The enclosed Traffic Operational Analysis (TOA) letter for the **New Castle Logistics Park** (Tax Parcel 12-013.00-007) development has been completed under the responsible charge of a registered professional engineer whose firm is authorized to work in the State of Delaware. They prepared the TOA in accordance with DelDOT's Development Coordination Manual and other accepted practices and procedures for such studies. DelDOT accepts this letter and concurs with the recommendations. If you have any questions concerning this letter or the enclosed review letter, please contact me at (302) 760-2167.

RE: Agreement No. 1774  
Project Number T201769002  
Traffic Impact Study Services  
**Task 5-New Castle Logistics Park**

Johnson, Mirmiran and Thompson (JMT) has completed the Traffic Operational Analysis (TOA) for New Castle Logistics Park. This task was assigned Task Number 5. The report is prepared in a manner generally consistent with DelDOT’s *Development Coordination Manual*.

**Site Map**

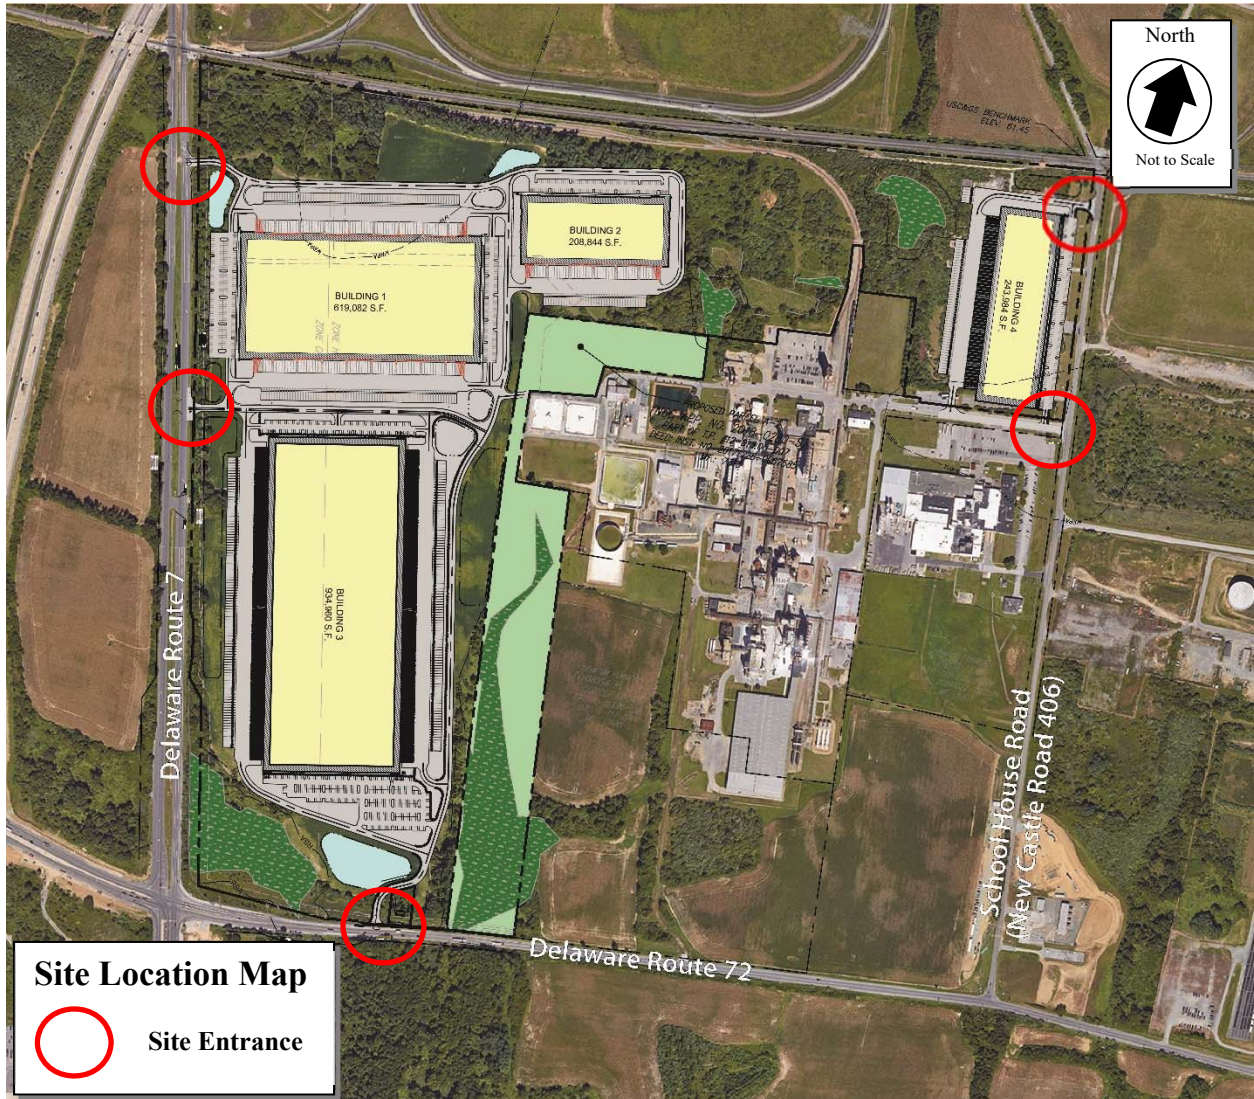
4. The developer should construct a rights-in/rights-out site entrance for the proposed New Castle Logistics Park development on Delaware Route 72 along the south side of the property, approximately 900 feet east of the intersection with US Route 13/Delaware Route 7, to be consistent with the proposed lane configurations as shown in the table below:

5. The developer should construct a full access site entrance for the proposed New Castle Logistics Park development on Delaware Route 7 along the west side of the property. Based on the Site Plan, the entrance is proposed approximately 2,250 feet north of the intersection with Delaware Route 72. However, the developer should coordinate with DelDOT Development Coordination Section to identify the exact location as there is an existing median opening approximately 1,800 feet north of the intersection with Delaware Route 72 that may conflict with the proposed entrance location. The full access entrance should be consistent with the proposed lane configurations as shown in the table below:

6. The developer should construct a rights-in/rights-out site entrance for the proposed New Castle Logistics Park development on Delaware Route 7 along the west side of the property, approximately 3,350 feet north of the intersection with Delaware Route 72, to be consistent with the proposed lane configurations as shown in the table below:

7. The developer should construct a full access site entrance for the proposed New Castle Logistics Park development on School House Road along the east side of the property, approximately 3,750 feet north of the intersection with Delaware Route 72, to be consistent with the proposed lane configurations as shown in the table below:

8. Any improvements needed for the existing shared entrance with the Formosa Plastics property will be determined through the Entrance Plan review process.
9. The developer should modify the School House Road intersection with Delaware Route 72 to be consistent with the proposed lane configurations as shown in the table below:
